## ADDENDUM TO THE CONTRACT

### CBJ-MIS & Server Room A/C Installation

Contract No. BE17-144

**ADDENDUM NO.:** TWO

**E100-R1**

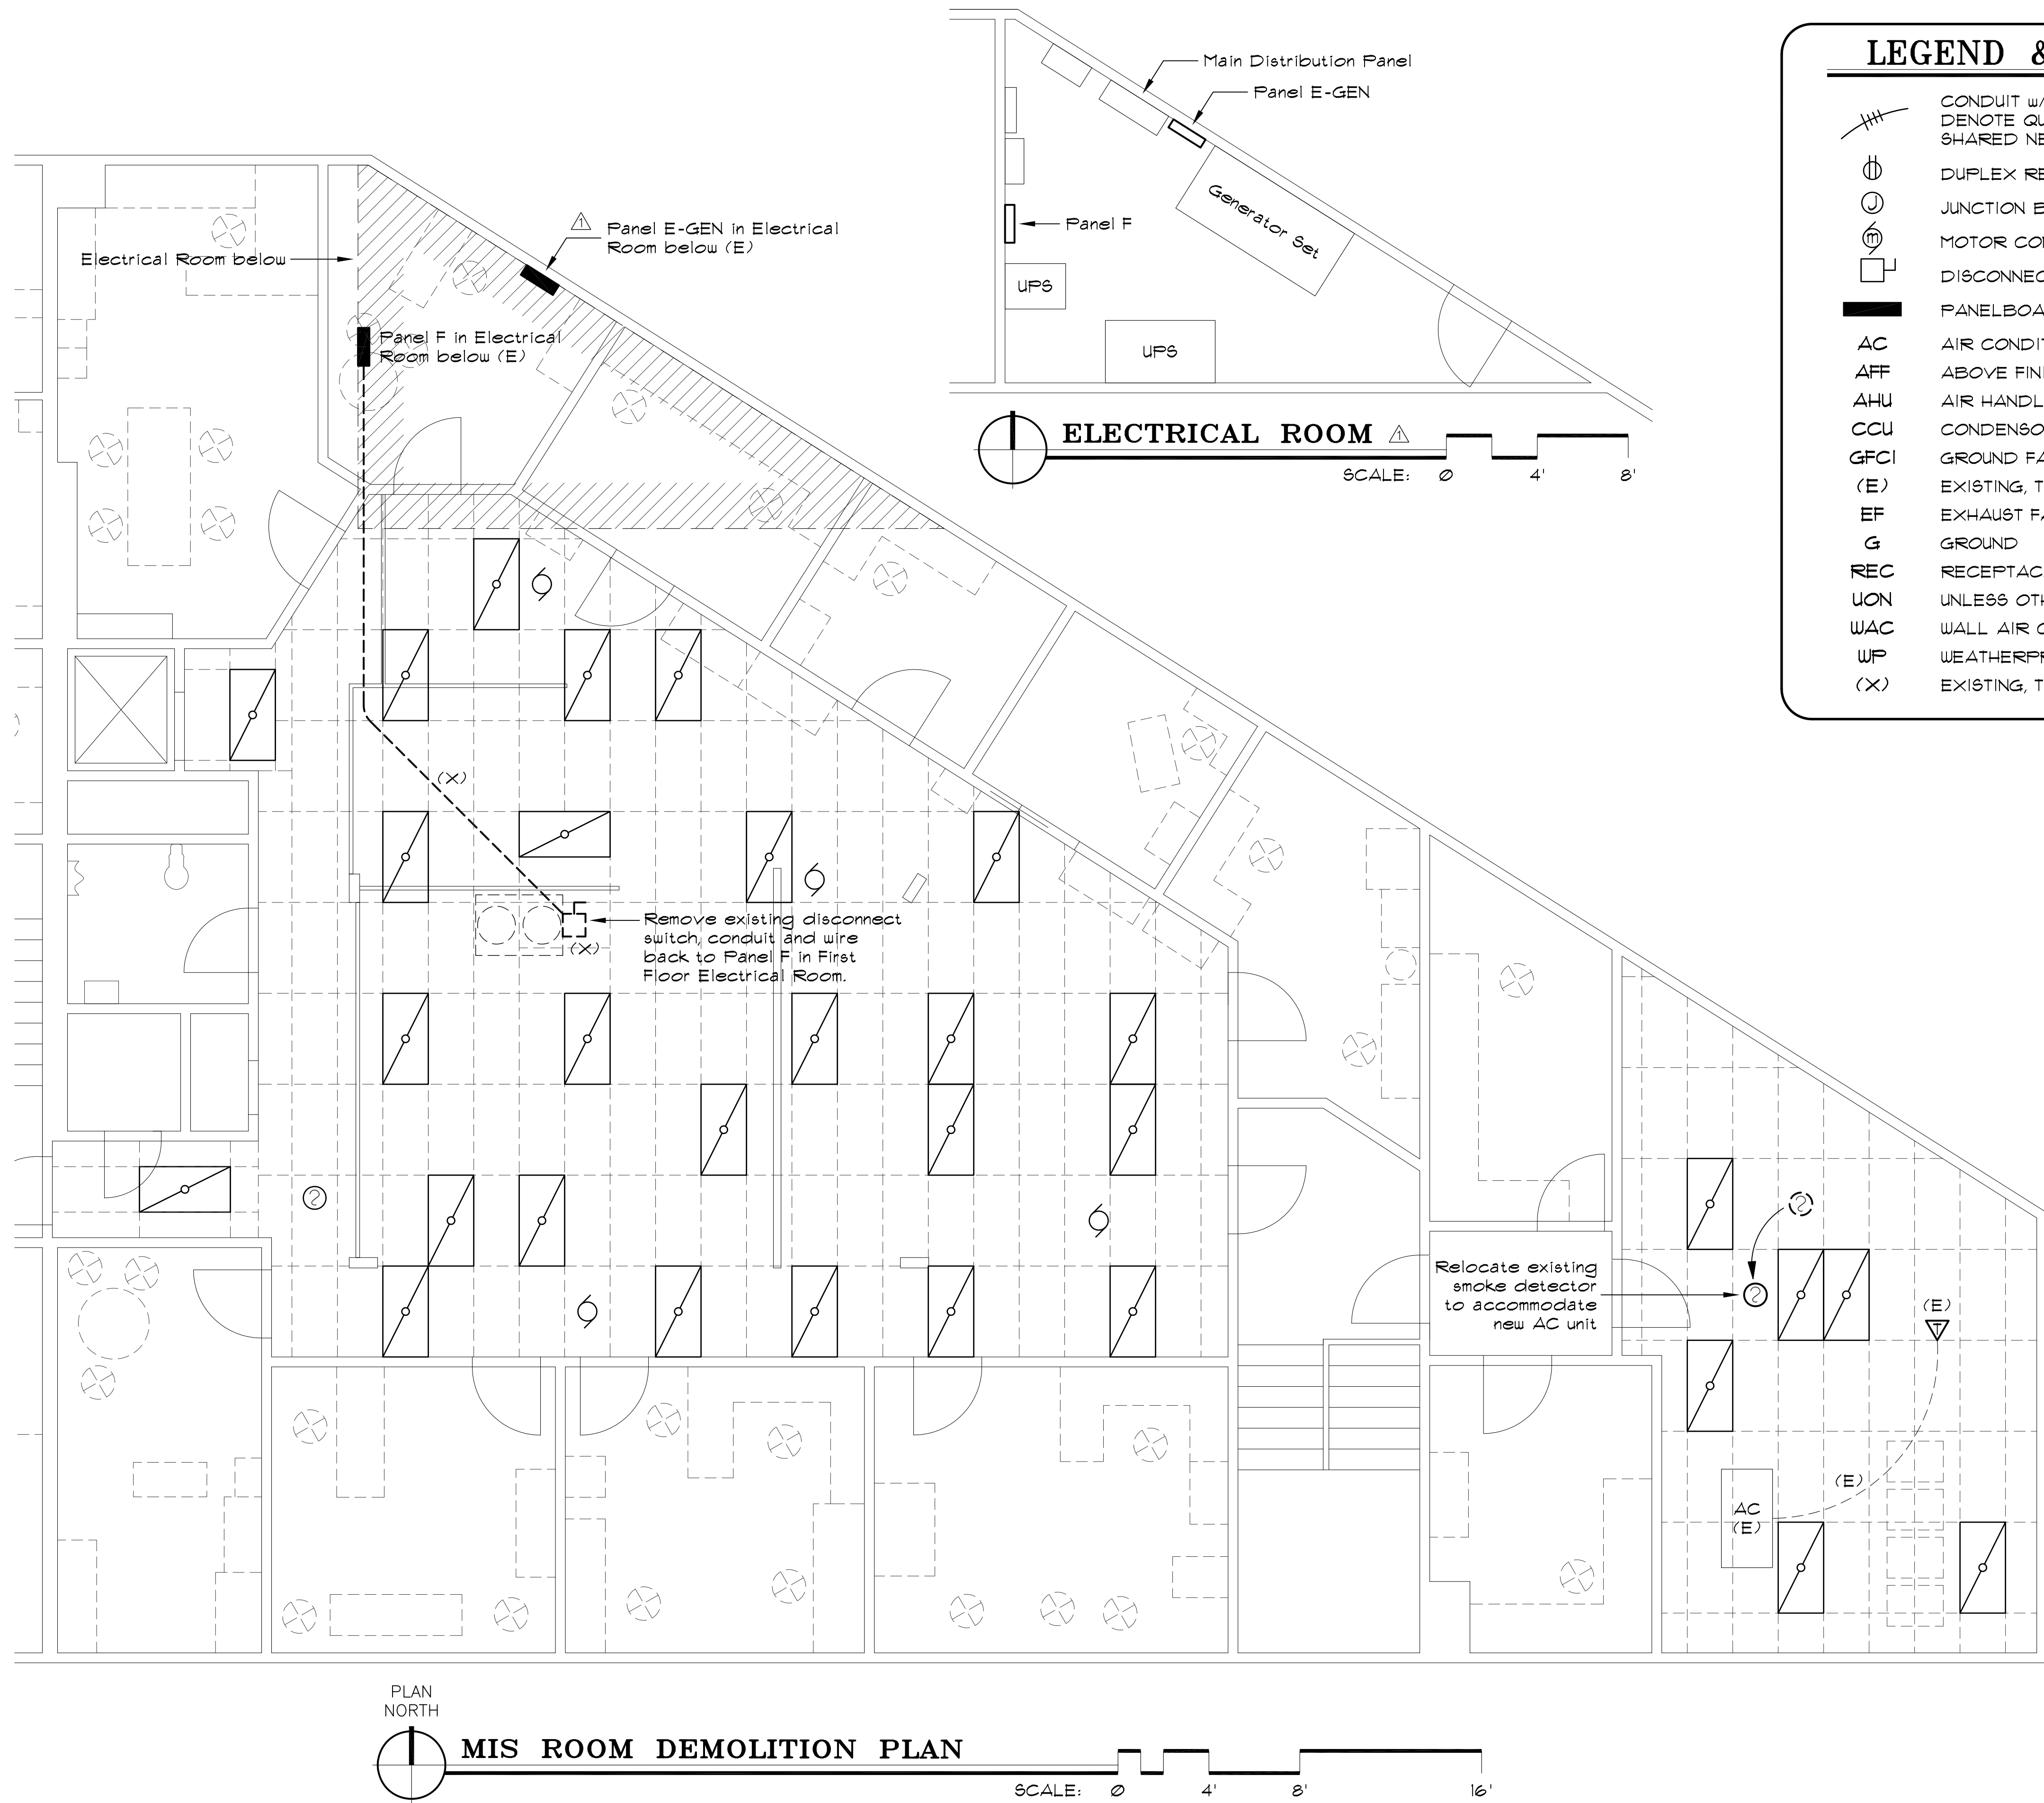
- Item No. 13 E100 MIS DEMOLITION PLAN, LEGEND, NOTES, **Remove** Sheet E100 DEMOLITION PLAN, LEGEND, NOTES and **Replace** with attached E100-R1 DEMOLITION PLAN, LEGEND, NOTES, REVISION DATE 1/18/17.

SHEET NO.  
**E200-R1**

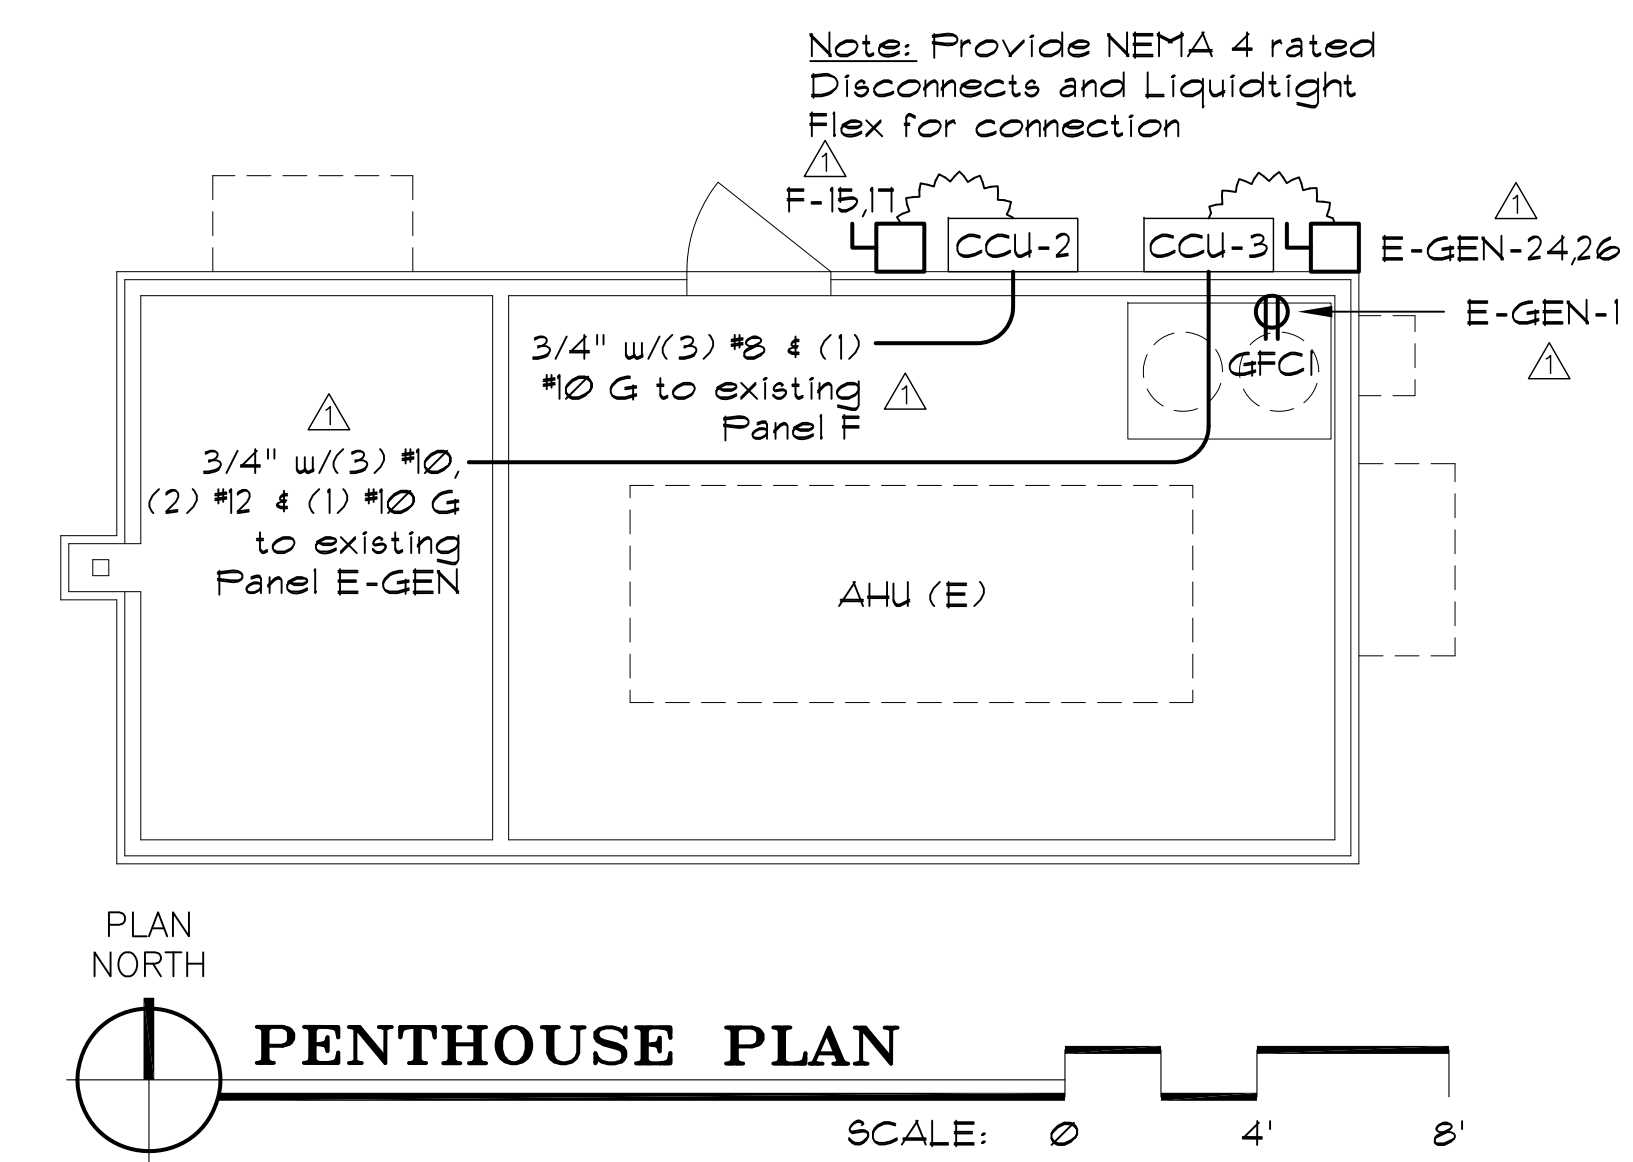
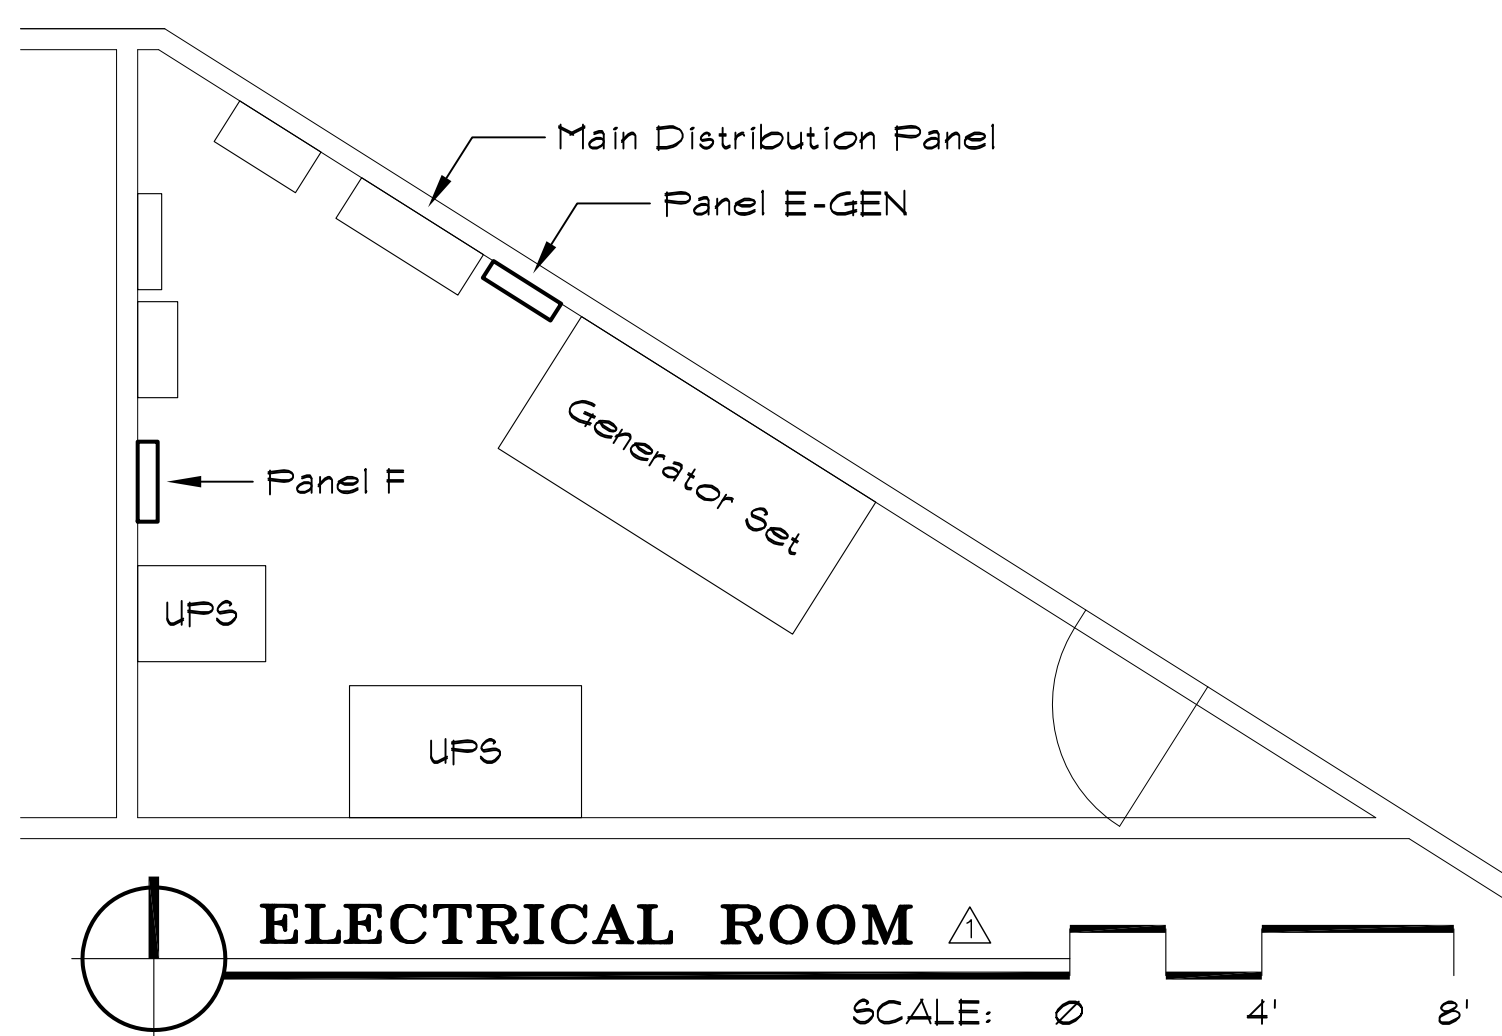
1. On site it was brought to our attention that the proper clearance in front of the new F2 panel in the Penthouse will not be to code. The AHU is approximately 34 inches from the wall. With the additional depth of the panel we will have 30" of clearance in front of the panel.

2. On drawing E200, Penthouse plan-are the disconnects for CCU 2 and CCU3 fused or are non-fused disconnects permitted?

3. For Panel F2 will a load center panel be permitted or is a panelboard required?

*Response:* Panel F2 has been eliminated. See the revised electrical drawings issued 1-18-17.

*Response:* Non-fused disconnects are permitted.

*Response:* Panel F2 has been eliminated. See the revised electrical drawings issued 1-18-17.

1. For CCU-2: Remove the existing 50/3 circuit breaker in Panel F (15,17,19) and replace with a 35/2 breaker (F-15,17). Install a filler plate in the remaining opening (F-19). Feed the new disconnect and Condensor Compressor Unit CCU-2 on the Penthouse with (3) #8 & (1) #10 G in 3/4" conduit as shown.
2. For CCU-3: Utilize the existing 30 ampere, two-pole (30/2) spare circuit breaker in Panel E-GEN-24,26. Feed the new disconnect and Condensor Compressor Unit CCU-3 on the Penthouse with (3) #10 & (1) #10 G in 3/4" conduit as shown.
3. For the new Condensate Pump: Utilize the existing 20 ampere, single-pole (20/1) spare circuit breaker in Panel E-GEN-1. Feed the new GFCI receptacle in the Penthouse with (2) #12 & (1) #12 G in the 3/4" conduit in paragraph 2 above.
